Technical Service Bulletin

Subject: A/C BLOWS WARM AIR	Bulletin No.: 07-001/17
	Last Issued: 02/15/2017

2016-2017 CX-3 vehicles with VINs lower than JM1 DK ***** 159395 (produced before November 01, 2016)

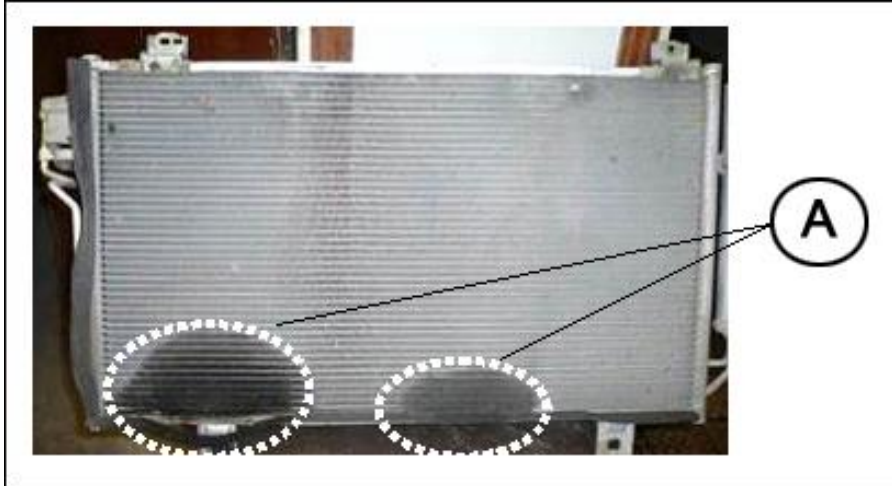
Some customers may complain about warm air from the climate control vents. This may be caused by condenser corrosion, causing a refrigerant leak.

1. Visually inspect the condenser for A/C refrigerant leak. Is there a visible trace of A/C refrigerant leak at location (A)?

2. Use a dealer supplied UV leak detection tool. Is there a trace of fluorescent liquid at location (A)?

3. Replace the condenser. Refer to MS3 online Workshop Manual CONDENSER REMOVAL/INSTALLATION [SKYACTIV-G 2.0].
